## Process Sheet

<b>Customer</b> :	CU-DAR001 Dart Helicopters Services	<b>Drawing Name</b> :	MID TUBE ASSEMBLY
<b>Job Number</b> :	41980		
<b>Estimate Number</b> :	10469		
<b>P.O. Number</b> :		<b>Part Number</b> :	D3391023
<b>This Issue</b> :	11/09/2008	<b>S.O. No.</b> :	
<b>Prsht Rev.</b> :	NC	<b>Drawing Number</b> :	D3391 REV H
<b>First Issue</b> :	//	<b>Project Number</b> :	N/A
<b>Previous Run</b> :	41979	<b>Drawing Revision</b> :	H
<b>Written By</b> :		<b>Material</b> :	
<b>Checked &amp; Approved By</b> :	JLD 08.9.11	<b>Due Date</b> :	10/10/2008
<b>Comment</b> :	Est. A 05.10.20 New Issue KJ/EC Est. B 06.02.10 ECN773 dwg rev.D EC est C 07.03.20 rev F dwg EC est D 07.03.28 re-format EC est E 07.10.31 ecn 1053P EC Est Rev:F ECN 1056 07-11-13 DD verified by: EC Est Rev:G 08-09-08 new process (ecn 08-510) DD verified by:EC Est Rev:H 08-09-10 revH as per dwg DD verified by:EC		
<b>Qty:</b>	1	<b>Um:</b>	Each

DRAWING NO. REV. H  
D3391 SHEET 1 OF 8

TITLE SCALE  
412 FLOAT SKIDTUBE NTS

**D3391-023 MID TUBE ASSEMBLY PARTS LIST**

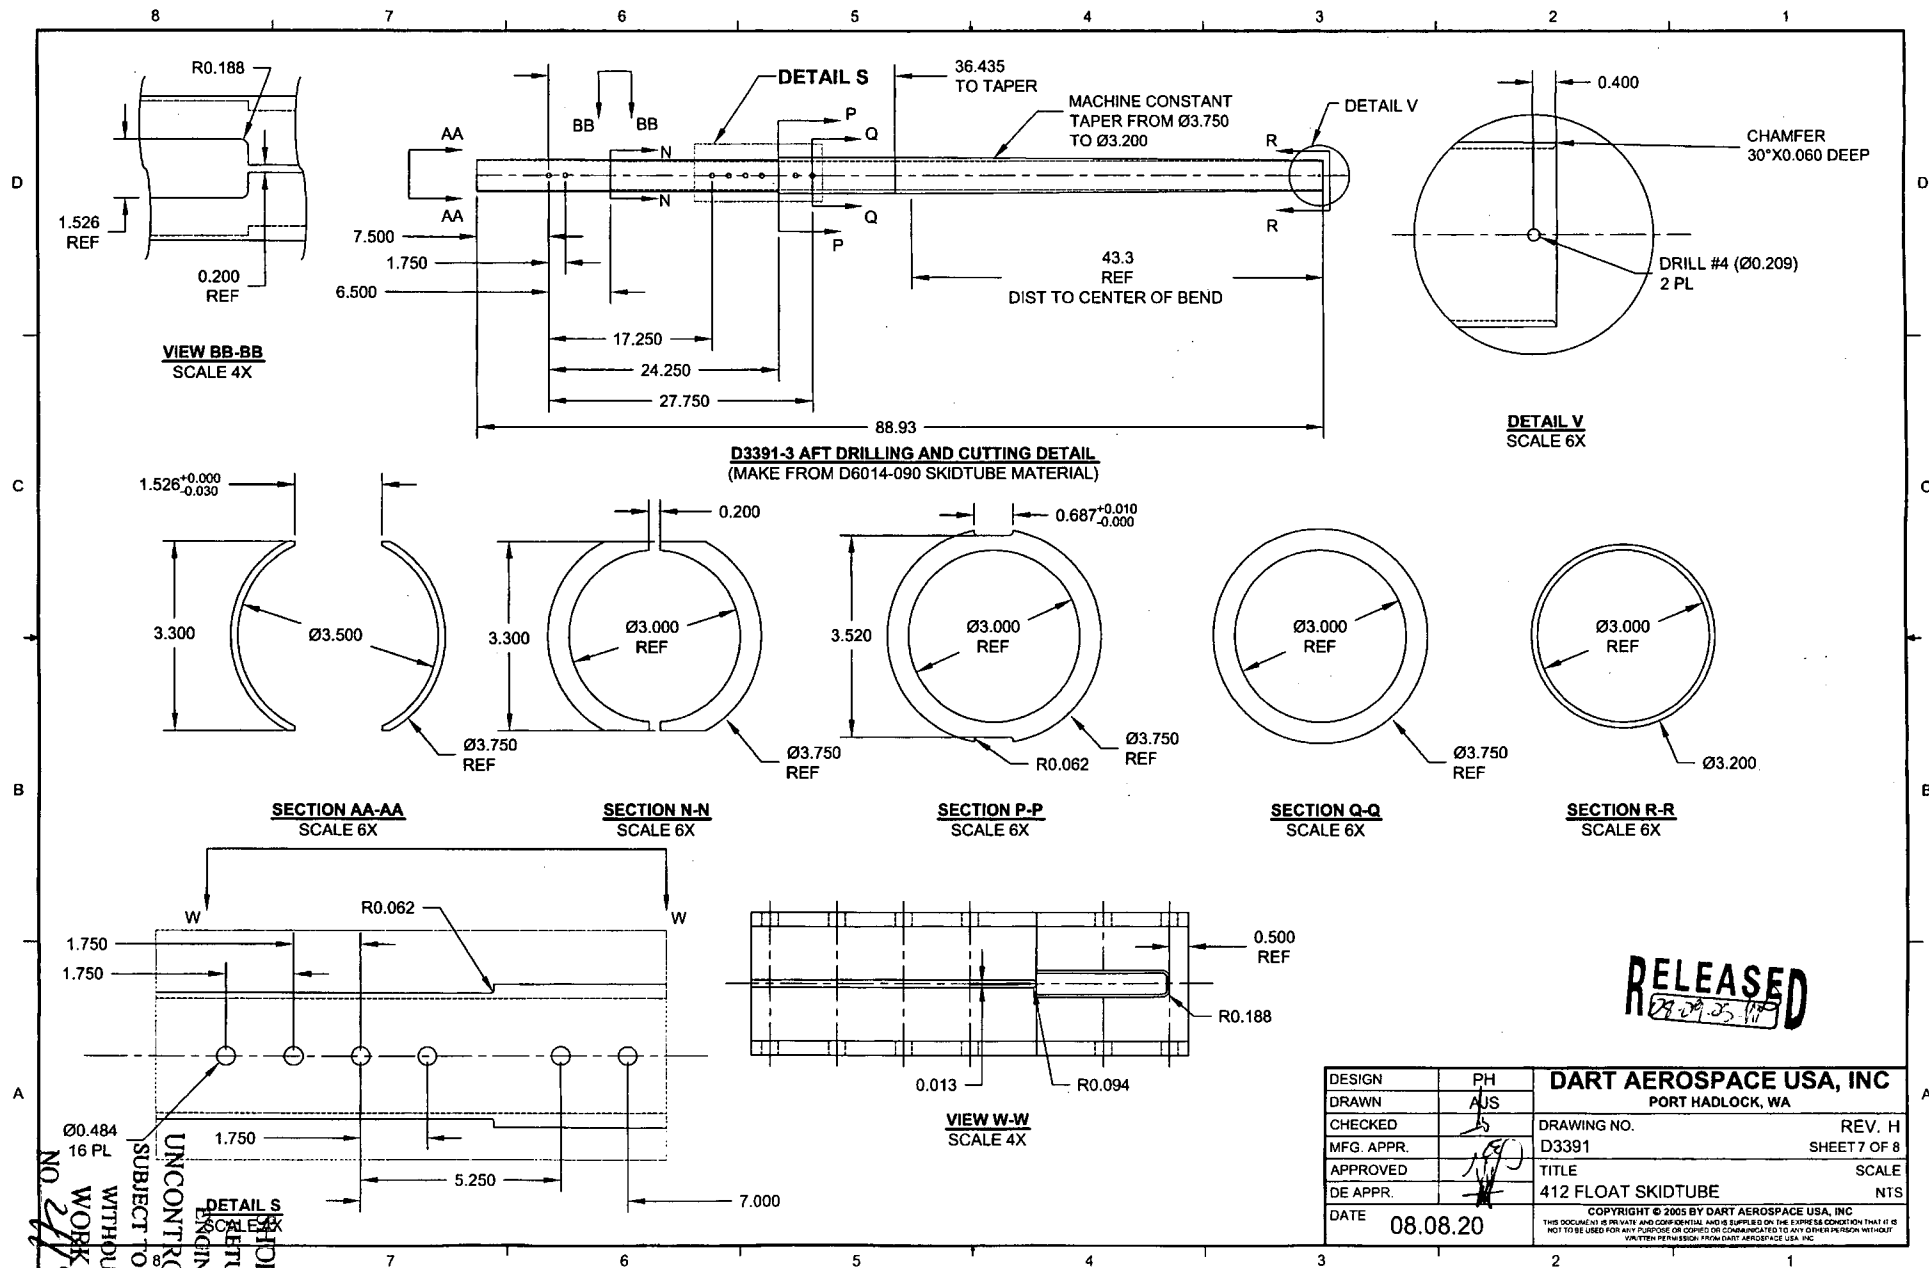
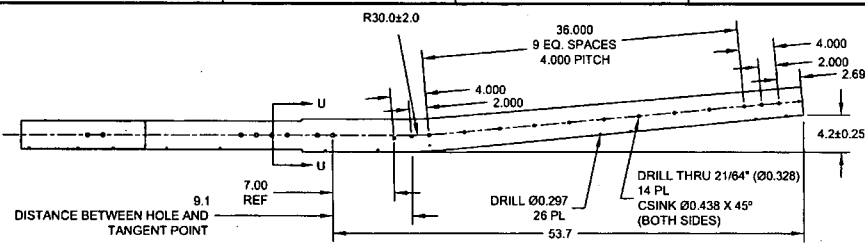
With reference to Section Y-Y of D3391 Rev H (page 5 and 6), nominally this section is 0.70 (+0.00/-0.10) from the skidtube ends. It is acceptable (for the affected batches only) to have this depth to be 0.800" (+0.000).

Anything above 0.800", I would recommend that the part be scrapped.

They drilled the 7 wearplate holes for the aft section on the D3391-023 mid-tube to 0.297 by mistake.

So do you think we can leave the holes at 0.297, or is it acceptable to weld, and re-drill to 0.250?

08.	<del>3.10</del> 3.10	The 7 aft wear plate holes were opened to 0.297 (same as the rest of the holes), instead of 0.250". R.C: Human error,	<i>[Signature]</i> QSIW12	Holes acceptable as is. Ensure to completely verify all dwg details prior to following through with I.P.R. instructions.	<i>[Signature]</i> H 8-11-10	<i>[Signature]</i> 08-11-10	<i>[Signature]</i> QSIW12	<i>[Signature]</i> 08-11-10

My preference would be to accept the holes at 0.297 diameter rather than plugging and re-drilling.
